## THE CITY OF SAN DIEGO TO THE PARK AND RECREATION BOARD

SUBJECT: UT Pocket Park General Development Plan

On September 11, 2013, the Design Review Committee voted unanimously to recommended approval of the GDP with the following recommendations. Design Review Committee recommendations are numbered below, with current park design responses directly below.

**U-T POCKET PARK/ SAN DIEGO RIVER PARK**

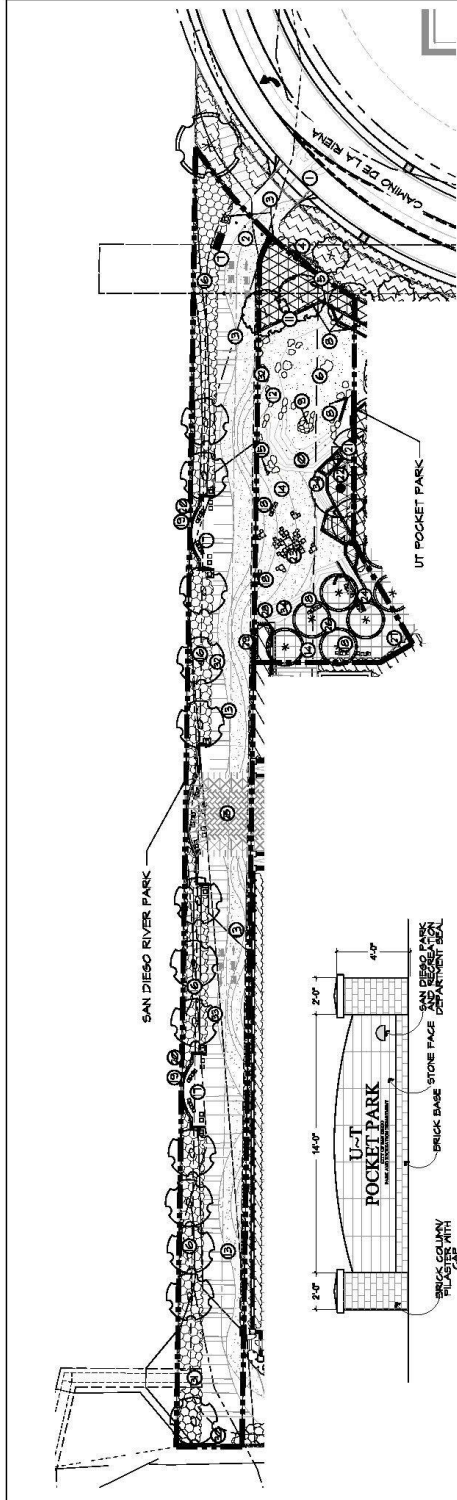
**1. The consultant team should carefully evaluate whether the existing Sycamore trees should be transplanted, as proposed, or if new specimen nursery trees should be used in lieu of transplanting, to determine the best approach to ensure long-term healthy trees within and adjacent to the park.**

**2. The monument sign and entry bollards should be of similar materials to provide continuity.**

**3. If possible, the parking lot along the edge of the park should be redesigned to provide a greater distance between the park and parking lot. If the parking lot cannot be reconfigured, the screening between the parking lot and the park should be enhanced to ensure the parking lot does not subjugate the goal of the park to offer a place of respite for park users.**

**4. The accessible walks between park levels are too linear and should be designed to appear more natural. This may also help eliminate the need for an extensive handrail system within the park.**

**5. The river overlook indicated along the fire lane should be more oriented with the park and less so with the site architecture. Adding a tree to the overlook will also help tie it into the park.**

**6. The linear aspect of the fire lane should appear to integrate with the park to blur the property line between the park and fire lane.**

**7. The site furnishings should be less eclectic and should be used to help tie the levels within the park together.**

**8. The bollards at the fire lane entry should be moved back into the site another 10 feet or so to make them less imposing on the approach to the park.**

**9. Look for ways to simplify the park's design. There appears to be too much variation in this small space.**

**10. Radius the end of the fire lane where it intersects with the walkway along the street.**

*Response: The plan has been adjusted to note "Focal Tree: Large boxed specimen or relocated from on-site".*

*Response: The monument sign has been modified to match the entry bollards.*

*Response: The head in parking along the park edge has been eliminated and the distance from the parking lot edge to the park has increased.*

*Response: The two accessible walks are both only 30ft long. The primary accessible walk is aligned to minimize out of direction movement for the primary direction of travel.*

*Response: The overlook was repositioned to align better with the main park plaza area. Trees are provided on either side of the overlook.*

*Response: The paving pattern integrates the park plaza and the fire lane. The fire lane is also functioning as a linear promenade for the San Diego River Park per the adopted Master Plan.*

*Response: The final set of site furnishings will be selected during the 'Construction Documentation' phase of the project and will be chosen to help tie together the pocket park and 'River Promenade'.*

*Response: The bollards have been moved to the edge of the ROW for Camino de la Reina.*

*Response: The paving pattern has been simplified to reduce the visual busyness of the park.*

*Response: The fire lane (River Promenade) intersection with Camino de la Reina has been designed to be consistent with direction from City LDR – Transportation.*
